SUBJECT: SUMMARY OF FEBRUARY 10, 1994, MEETING WITH DUKE POWER COMPANY ON
RCS FLOW MEASUREMENT METHODOLOGY

COMMENTS ON PROPOSED TS CHANGE FOR CATAWBA AND MCGUIRE UNITS 1&2 FOR RCS FLOW-RATE MEASUREMENT - (TS 4.2.5.3)

QUESTIONS ON PROPOSED TS CHANGE FOR CATAWBA/MCGUIRE RCS FLOW-RATE MEASUREMENT

Figure 3.2-1 Reactor Coolant System Total Flow Rate Versus Rated Thermal Power - Four Loops in Operation

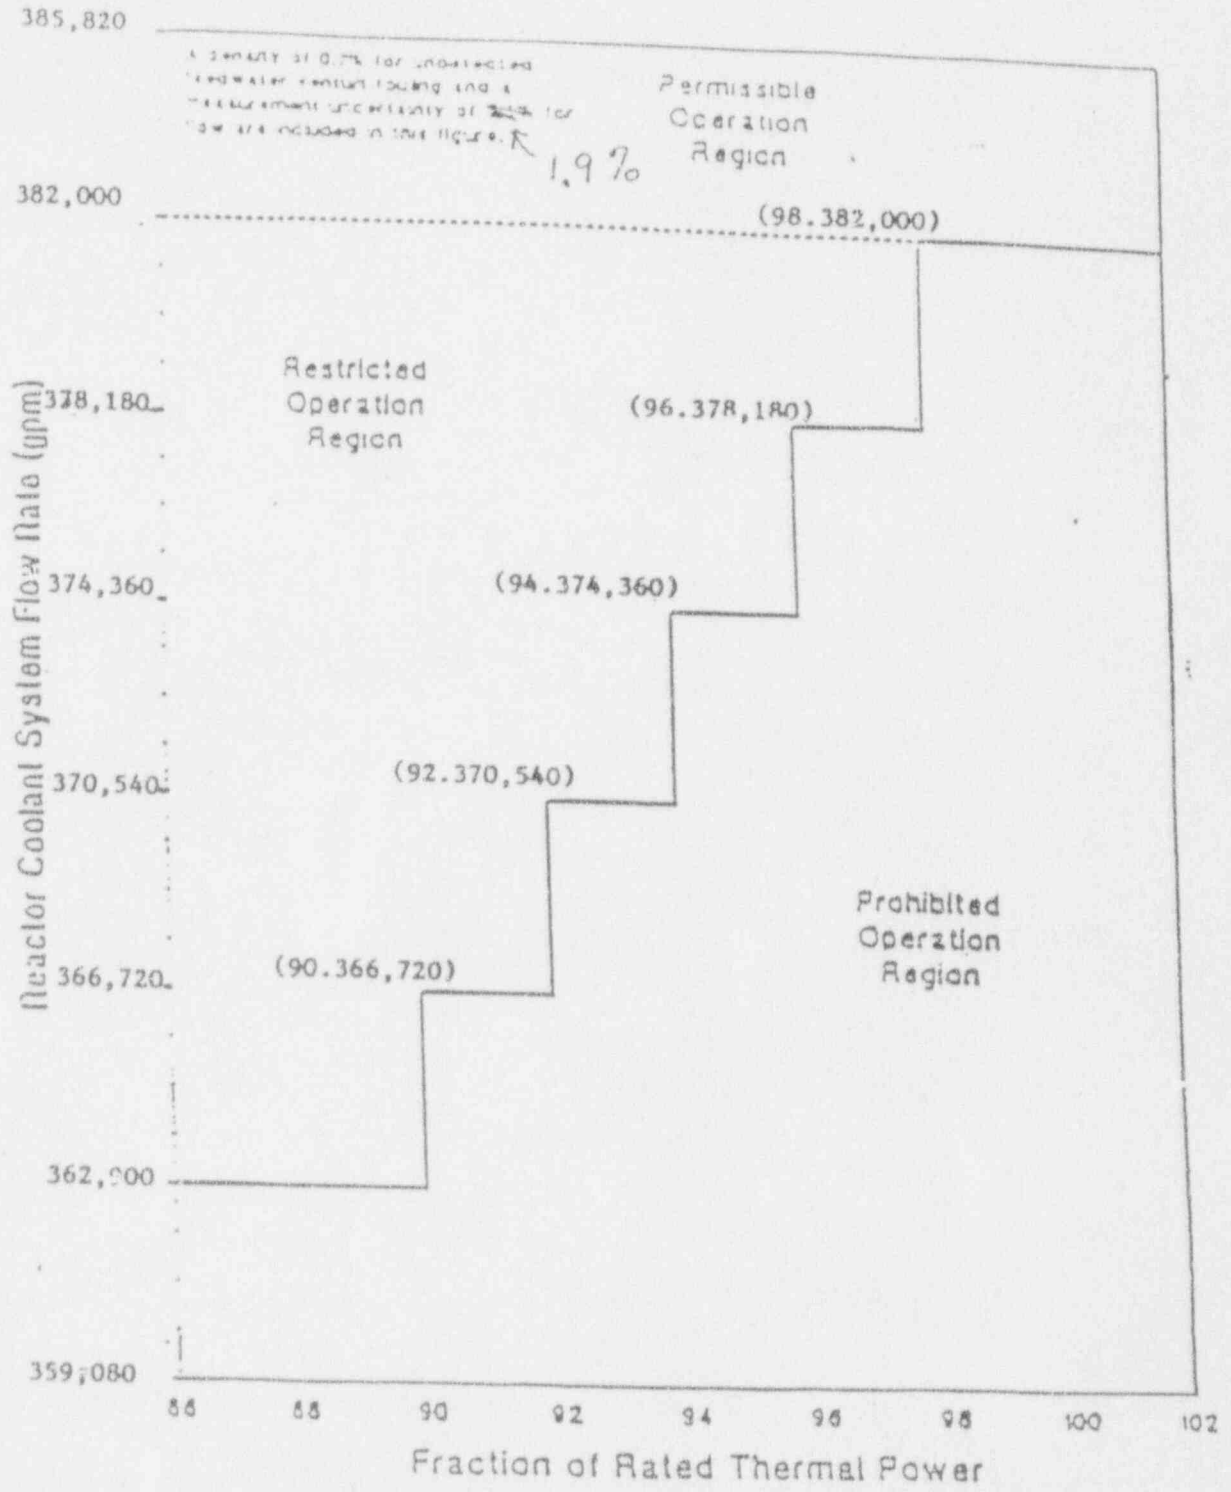
1. DPC states in the TS for Catawba, Figure 3.2-1, "Reactor Coolant System Total Flow Rate Versus Rated Thermal Power - Four Loops in Operation," that "A penalty of 0.1% for undetected feedwater venturi fouling and a measurement uncertainty of 1.9% are included in this figure." Is this flow measurement uncertainty of 1.9% (2.0% with the fouling penalty) what DPC plans to assign to the elbow tap meter reading? Please submit the flow measurement uncertainty (FMU) analysis that supports the FMU value. An FMU is required when there are changes made that effect the method of

- 1. DPC states in the TS for Catawba, Figure 3.2-1, "Reactor Coolant System Total Flow Rate Versus Rated Thermal Power - Four Loops in Operation," that "A penalty of 0.1% for undetected feedwater venturi fouling and a measurement uncertainty of 1.9% are included in this figure." What is flow measurement uncertainty of 1.9% (2.0% with the fouling penalty) what DPC plans to assign to the elbow tap meter reading? Please submit the flow measurement uncertainty (FMU) analysis that supports the FMU value. An FMU is required when there are changes made that effect the method of measuring RCS flow (Ref. 3).**

Flow Method Comparison

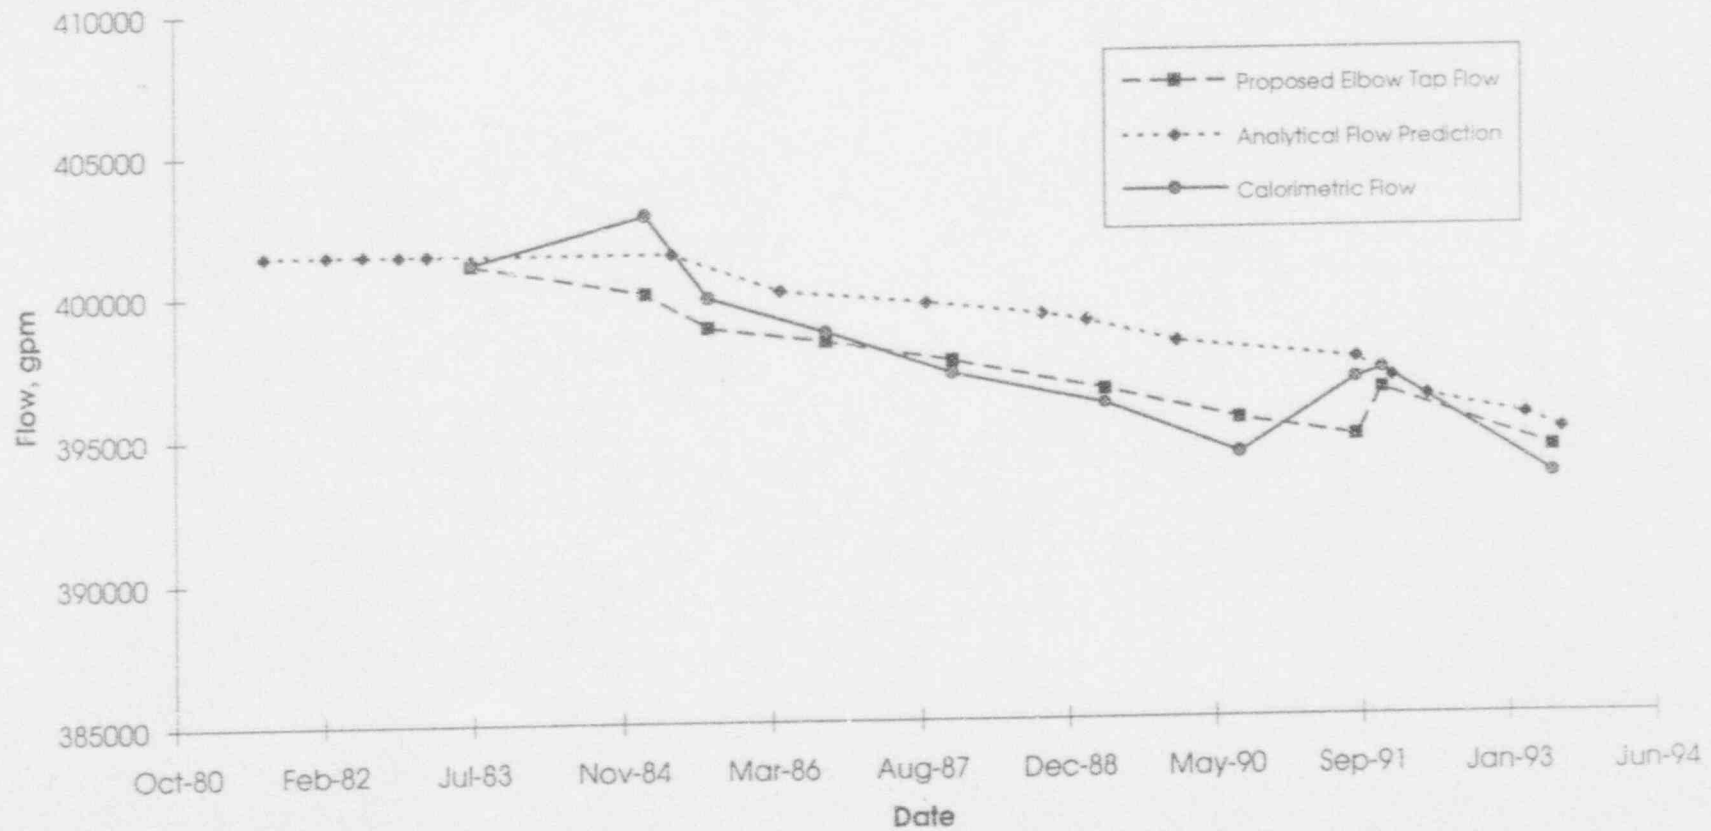
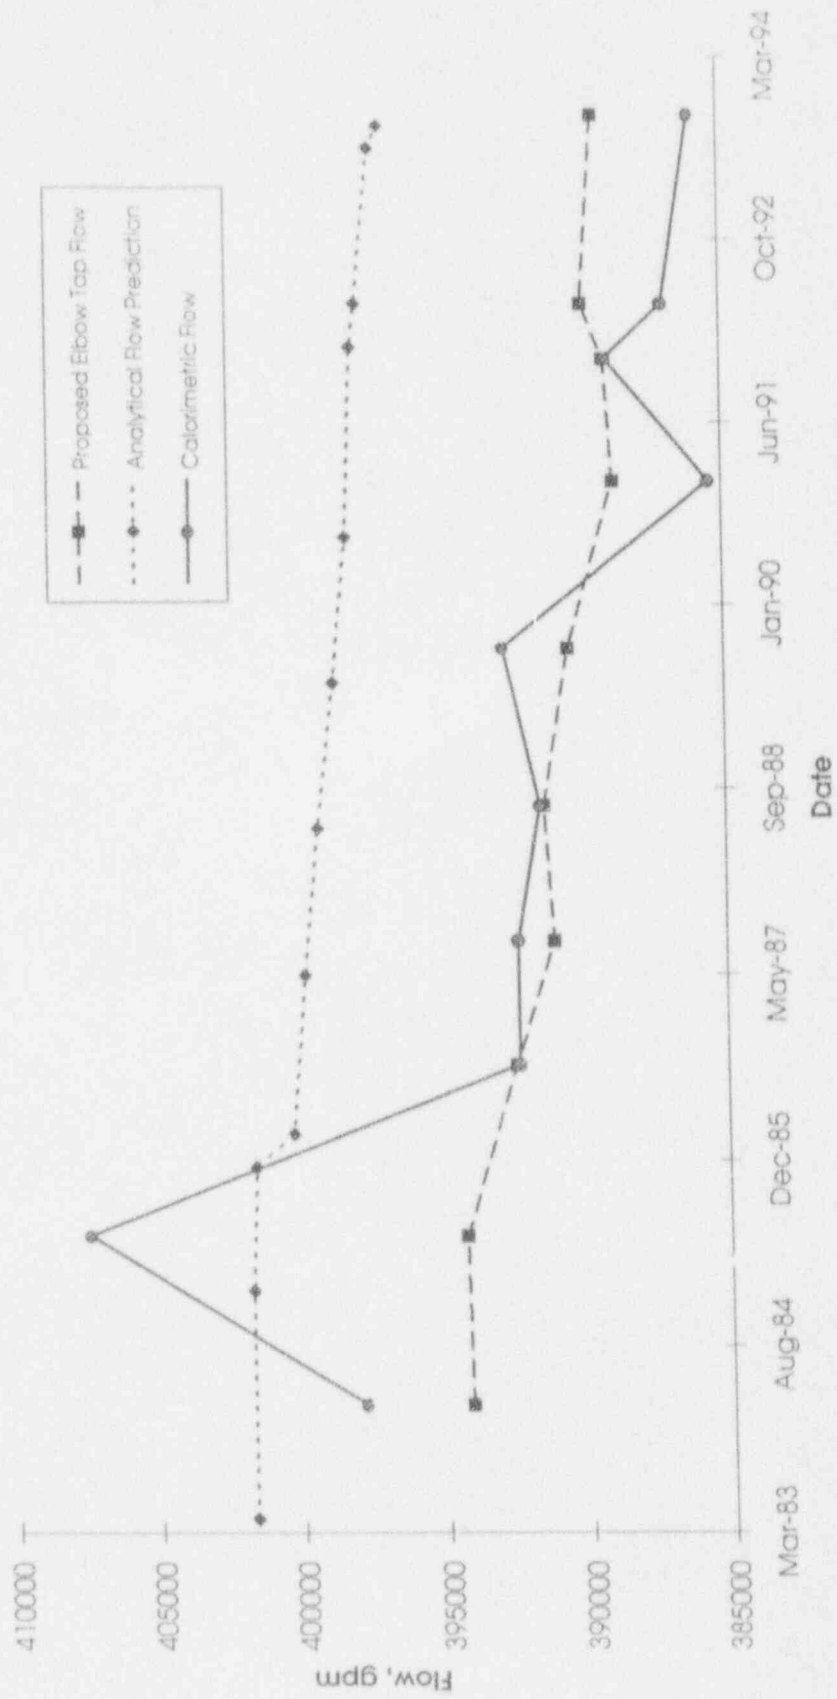
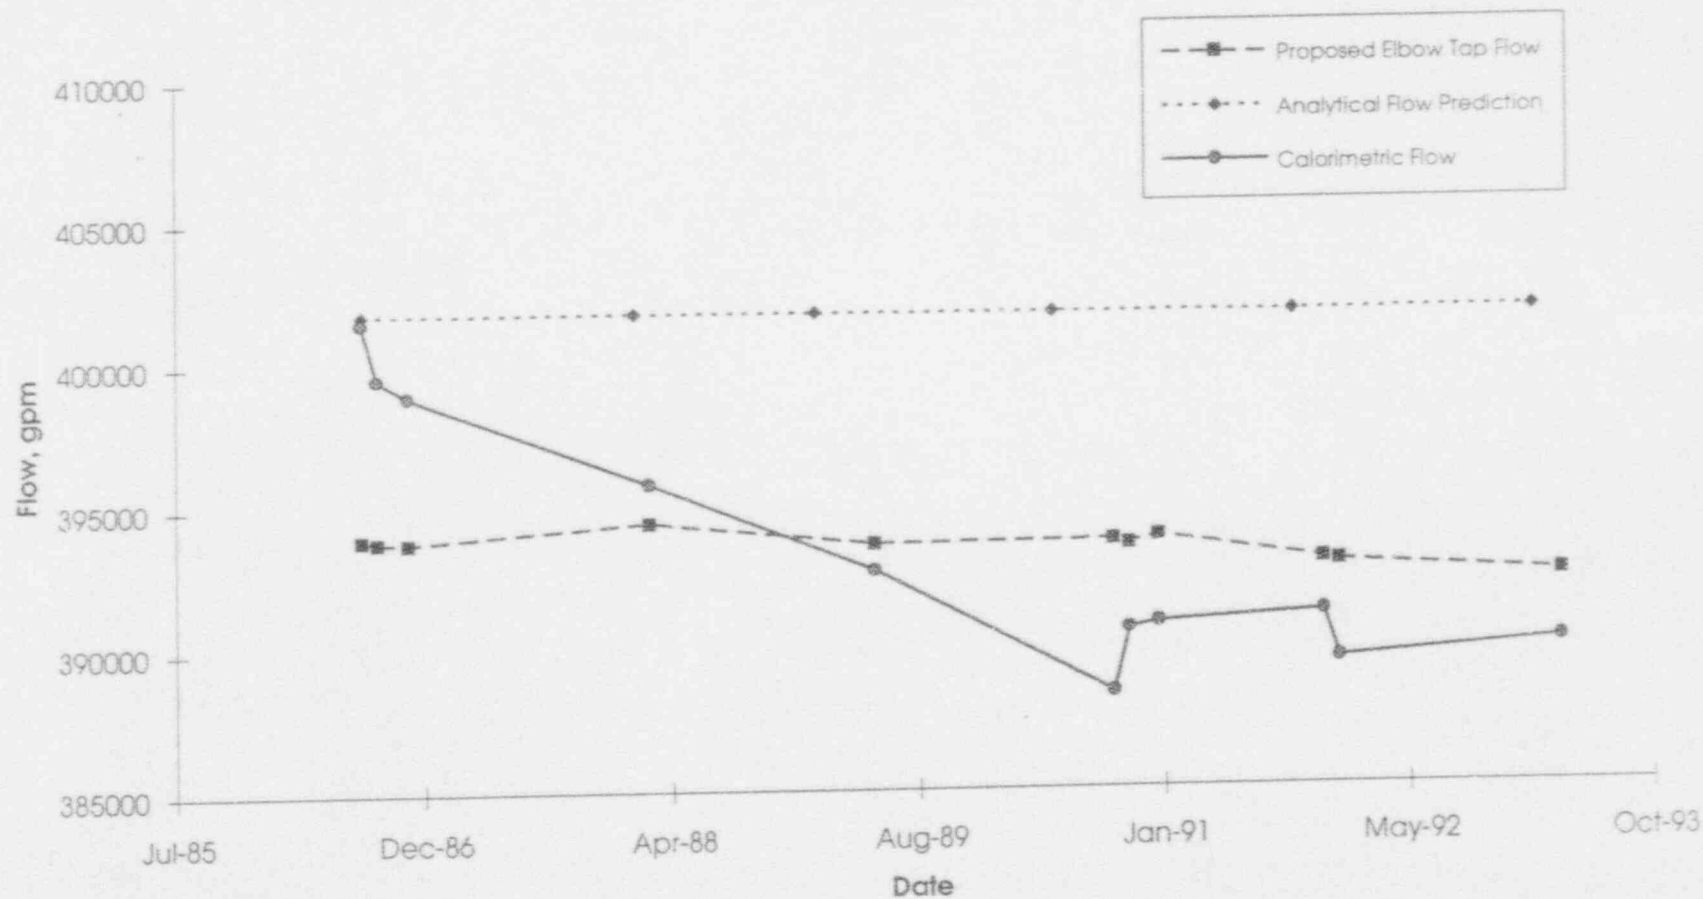
7. For question D1c, you provided Figures 1 - 4 of Attachment 3.

The comparison between the calorimetric and the proposed method of flow measurement is shown in Figures 1 - 4 of Attachment 3. Data from Prairie Island and other plants was not used to develop this method.

Figure 3

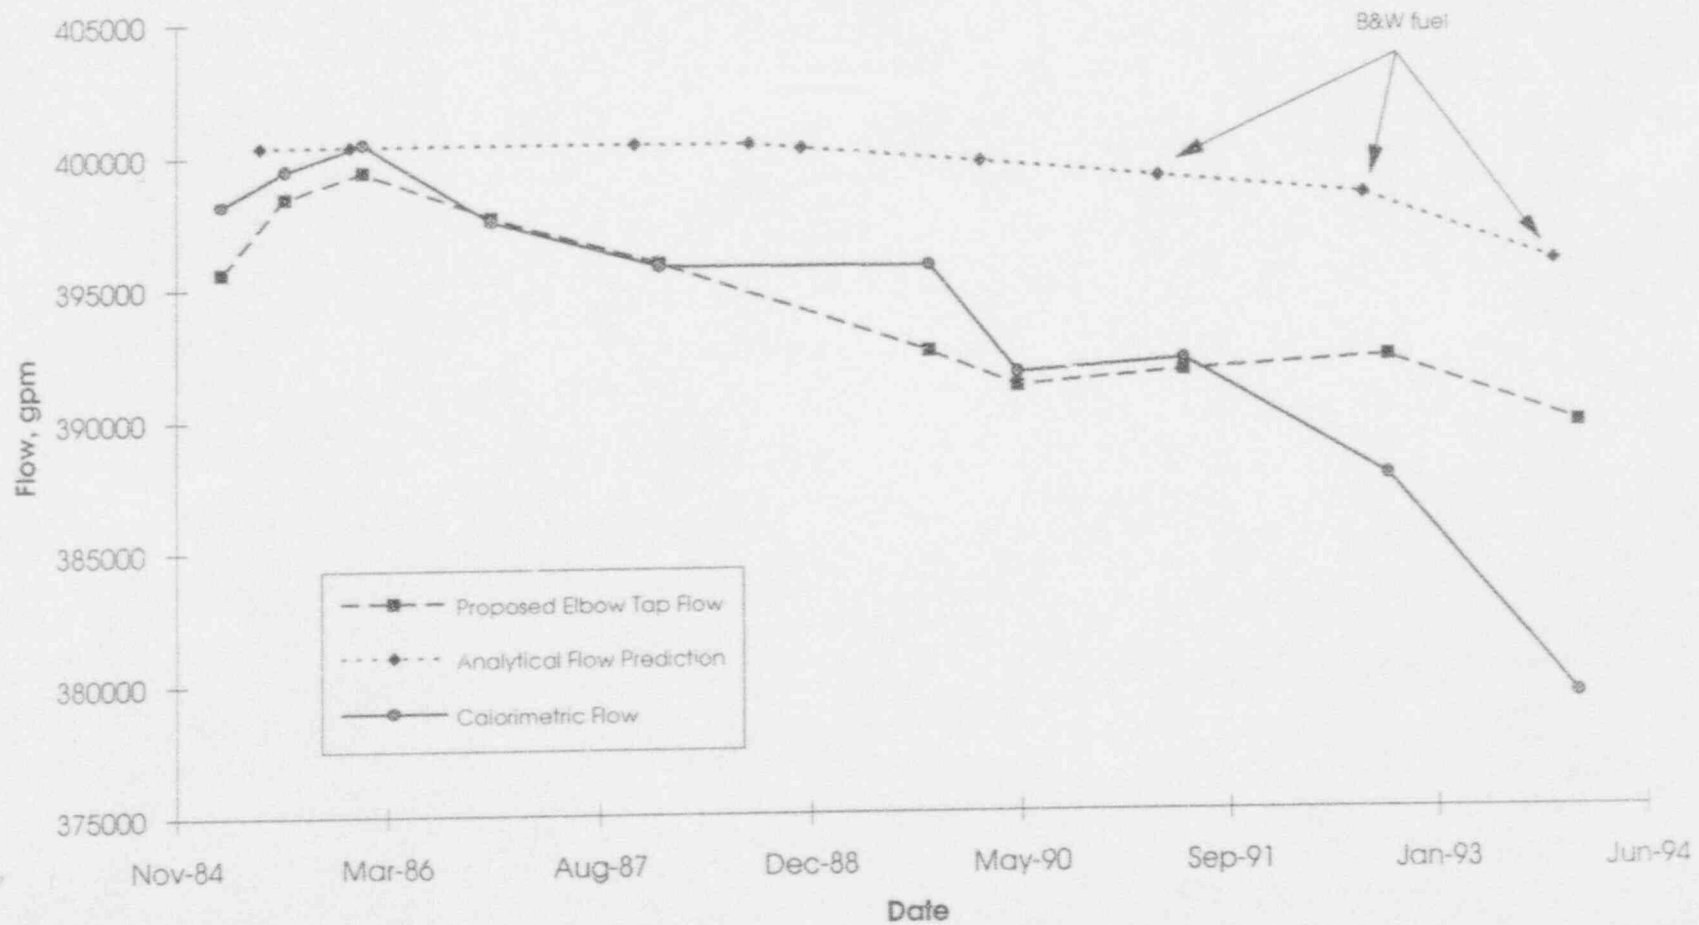
The plot for the calorimetric flow rate has generally close agreement with your proposed elbow tap method, except for the data point taken after December 88. However, the calorimetric flow rate deviates sharply

lower from your proposed method for the data taken after September 91.

(a) Please explain the reason for the greater deviation experienced for Figure 3 for data taken after September 91. Is this from an increased radial peaking profile in your low leakage core loading? If so, do you have plans for further increases in this profile?

(b) Please provide information on the effect of this large increase in SG tube plugging on the RCS flow rate and also the effect of hot leg streaming for this cycle on RCS flow rate. Is this reduction in RCS flow rate for this current cycle mostly due to SG tube plugging rather than from hot leg streaming? If so, is this not a realistic reduction in flow rate, rather than a false indication from an inaccurate hot leg reading?

Figure 3 Measurement error

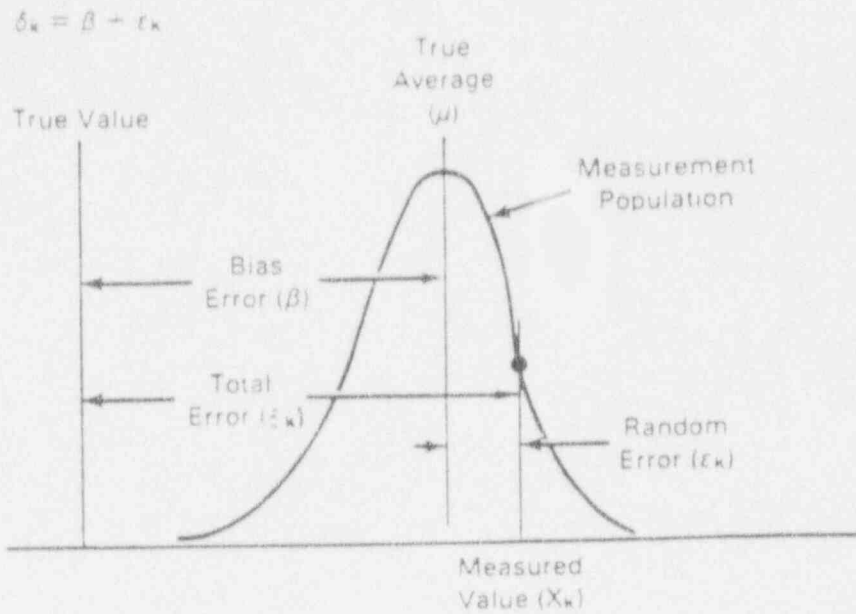
4. Reference 1 presents the general method for assessing uncertainties. Figure 3, measurement error, taken from Reference 1, shows that the measurement error is composed from the effect of the sensing path from the sensing element to the measurement output of the desired value. This error is shown to be composed of the effects of normal distribution and a bias. Figure 4 from Reference 1 is a schematic of components used for direct measurement of a quantity and includes output transmission, signal conditioning and readout, A/D conversion and digital computation.
